VILLAGE SQUARE ADDITION

Re: S/D97-75 -- Final Plat of VILLAGE SQUARE ADDITION

At the regular meeting of the Subdivision Committee of the Metropolitan Area Planning Commission on Thursday, November 20, 1997, the above captioned plat was considered. The action of the Committee was to approve the final plat, subject to the following:

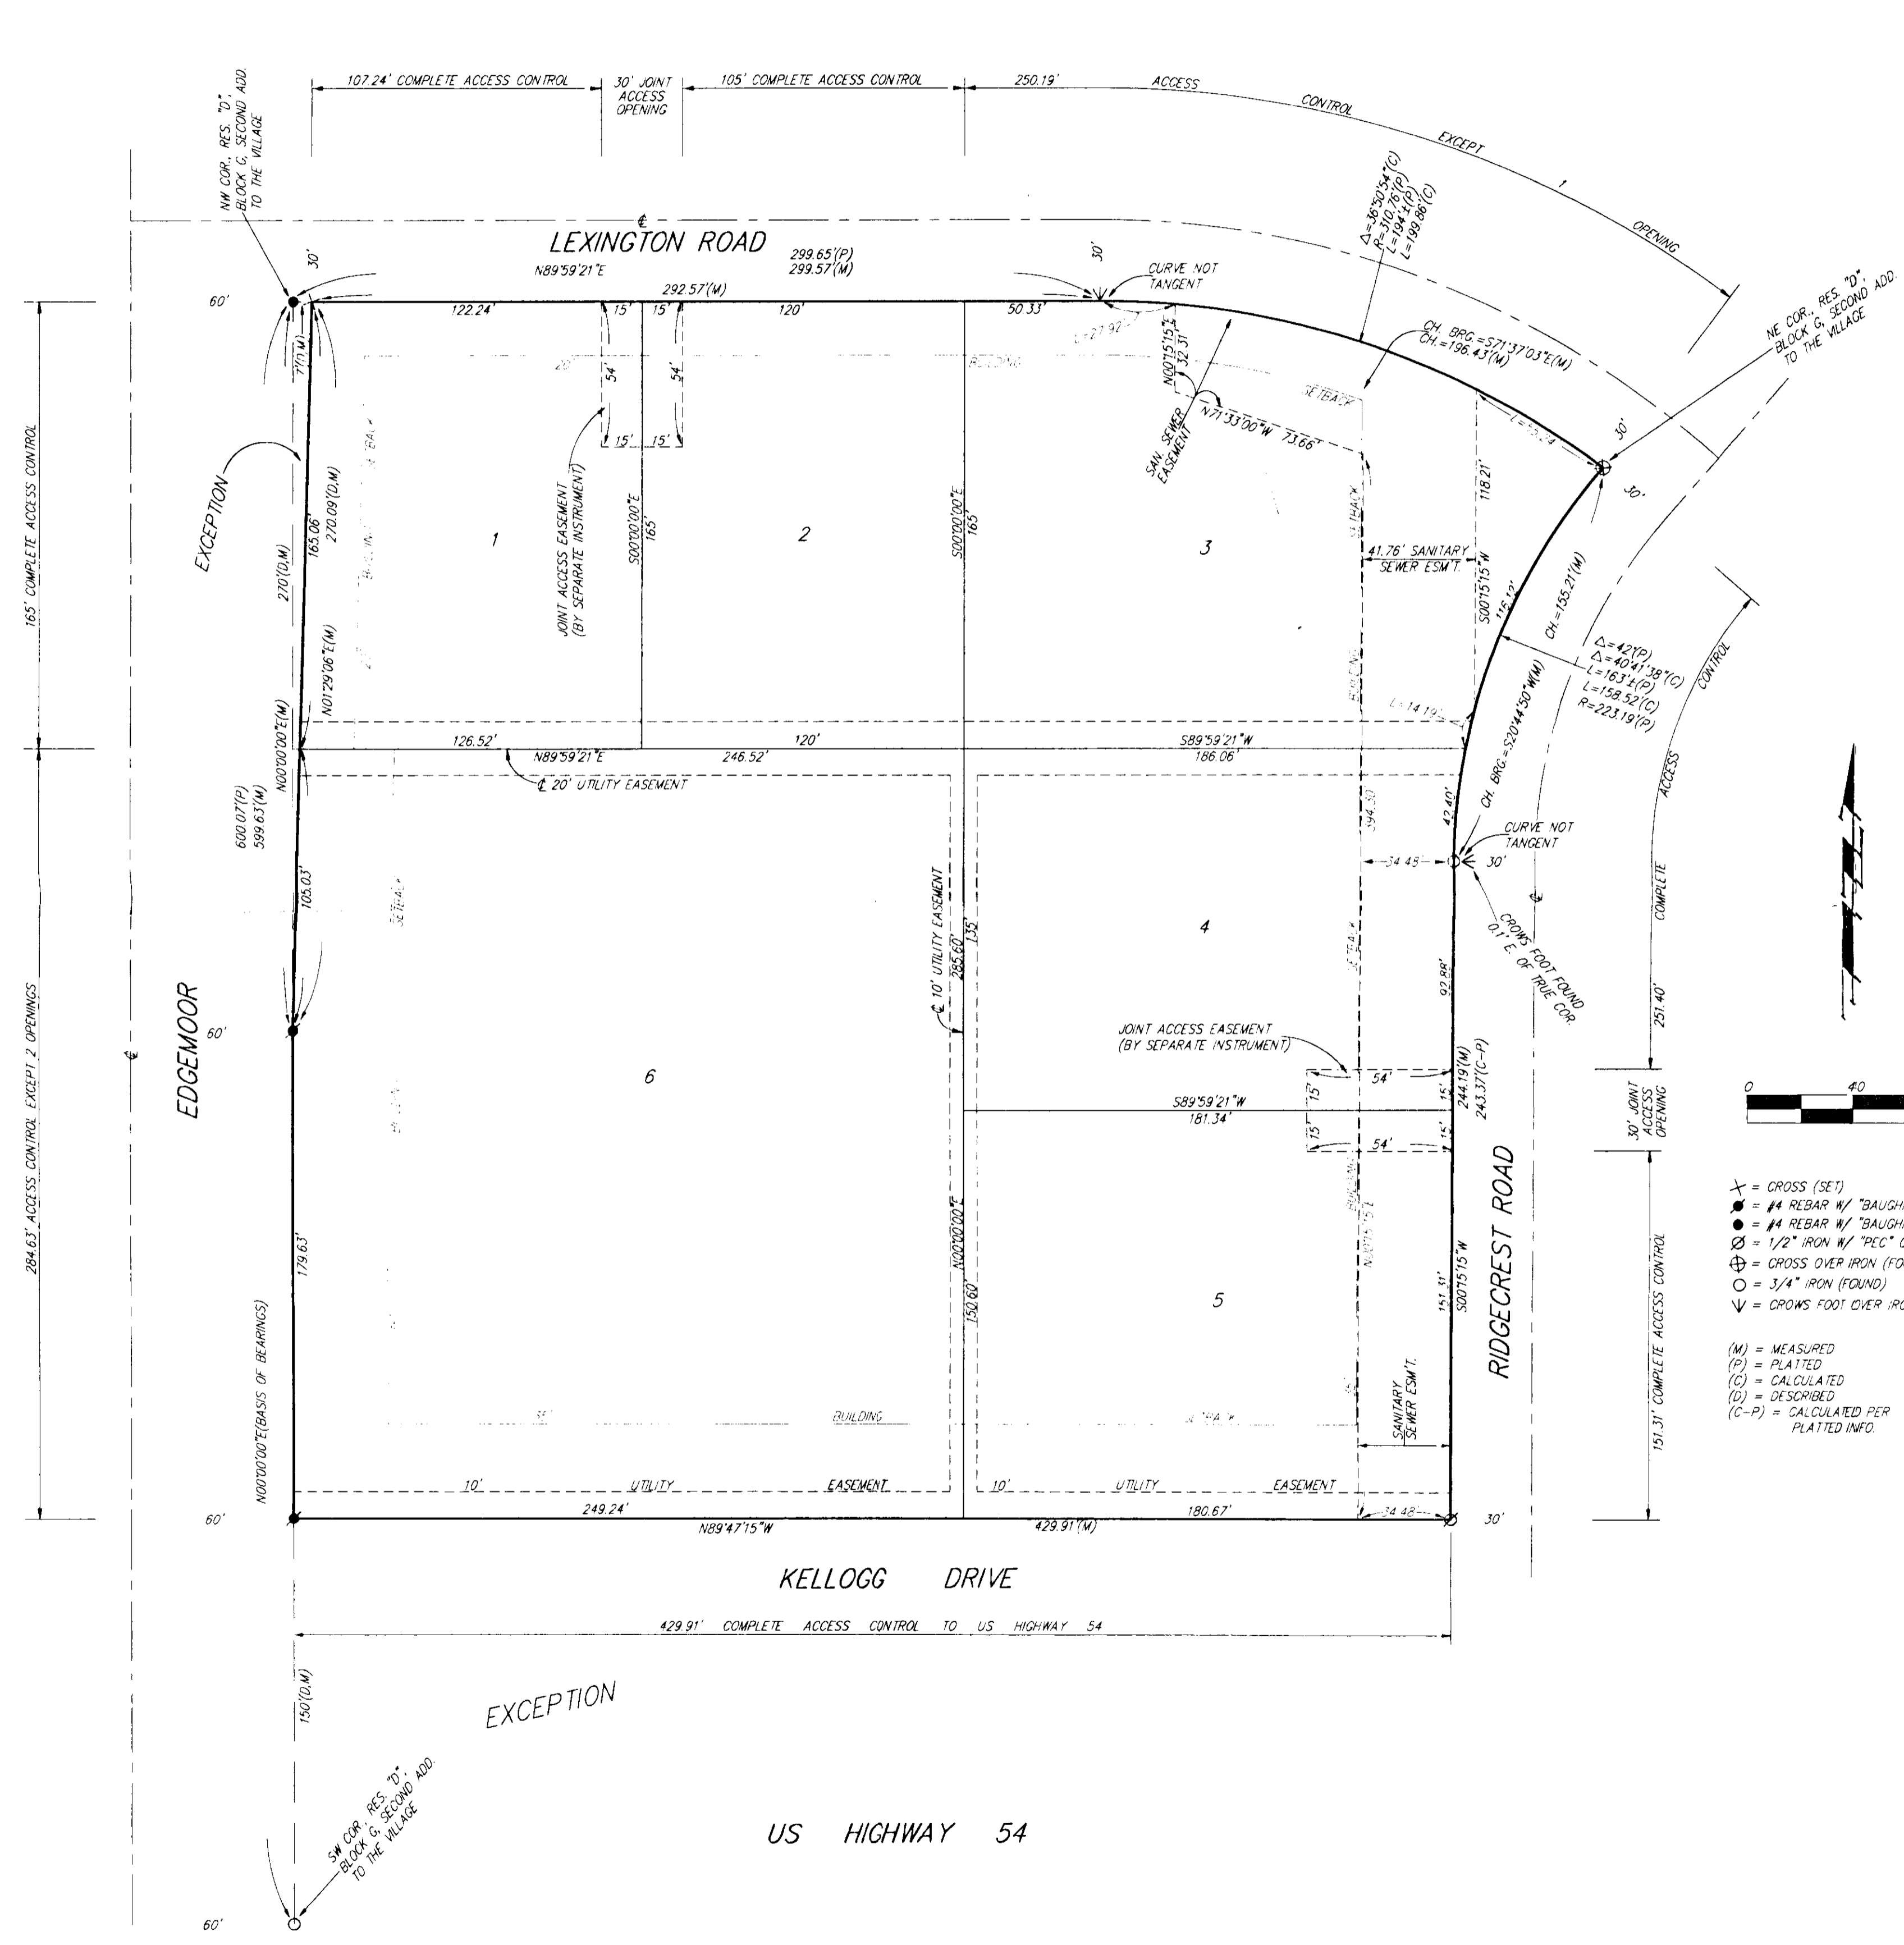
- A. It appears existing sewer and water service are available to the site. Engineering will need to comment on any guarantees or easements needed. City Engineering requests a sanitary sewer easement to coincide with the proposed location of the sewer. A temporary easement will be needed to cover the existing sanitary sewer lines which are to be abandoned (as denoted on the plat) unless abandonment of the lines will occur before the plat is recorded.
A guarantee for extension of the water line to Lot 2 will be required.

- B. Engineering needs to comment on the status of the applicant's drainage plan. The drainage plan is acceptable to City Engineering.
- C. Traffic Engineering needs to comment on the acceptability of access controls. Distances should be shown for all segments of access control. On the final plat tracing, since the site is within the City limits of Wichita, the plattor's text shall note that the access controls are being dedicated to the City of Wichita and that the location of the openings are subject to the approval of the City Engineer. The applicant shall guarantee the closure of any driveway openings being located in areas of complete access control or that exceed the number of allowed openings. Traffic Engineering has approved the following proposed access controls: two openings from lot 6 to Edgemoor, complete access control from Lot 1 to Edgemoor, two openings along Lexington Road, and one opening along Ridgecrest Road. Planning Staff has indicated the need for complete access control along Kellogg Street until the frontage road is constructed.

- E. The proposed joint access easements will need to be established by separate instrument. Initial construction responsibilities and future maintenance of the driveways within the easements should be addressed by the text of the instrument.

- L. The representatives from the utility companies should be prepared to comment on the need for any additional utility easements to be platted on this property. **The representative from KG&E has asked for additional easements, which have been incorporated on the final plat.**
